# HYUNDAI Technical Service Bulletin

Group	CAMPAIGN
Number	06-01-010
Date	OCTOBER, 2006
Model	2007 ENTOURAGE

Subject  
**STOP LAMP SWITCH WIRING  
 SERVICE CAMPAIGN 078**

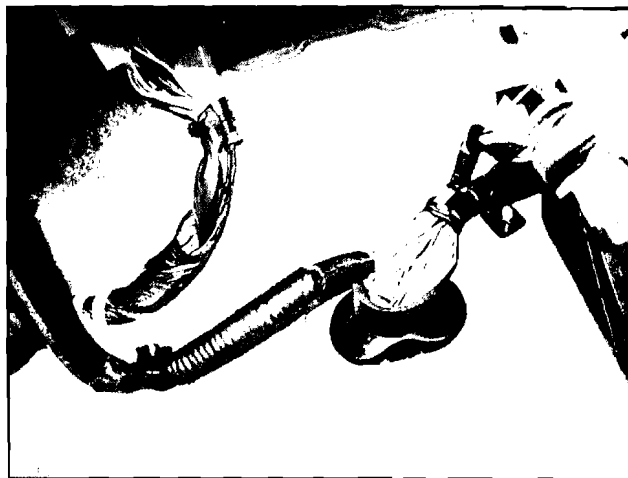
3. Locate the stop lamp switch wiring as shown in photo.

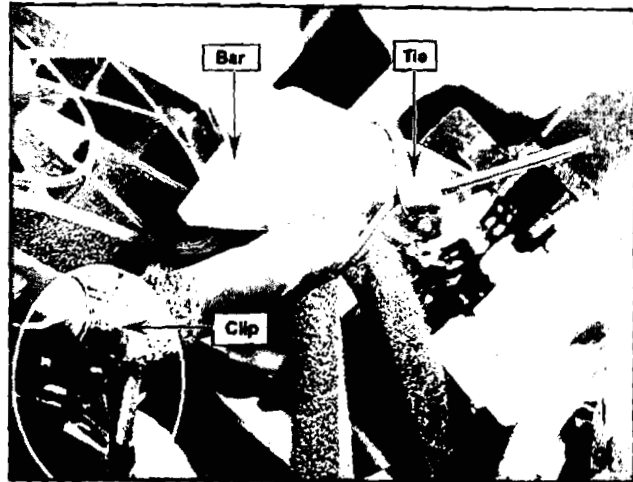
4. Tie the stop lamp switch wiring and the front wiring harness with a plastic tie wrap as shown in the photo. This procedure will pull the stop lamp switch wiring to the arrow direction to create a gap between the wiring and the steering column shaft.

5. Tie wrap the stop lamp switch wiring to the steering column shaft guide bar. Verify that the clearance between the stop lamp switch wiring and the steering column shaft is 26 mm (~1 inch) or more.
6. Cut off the excess plastic tie wrap. Be careful not to damage the vehicle's wiring.
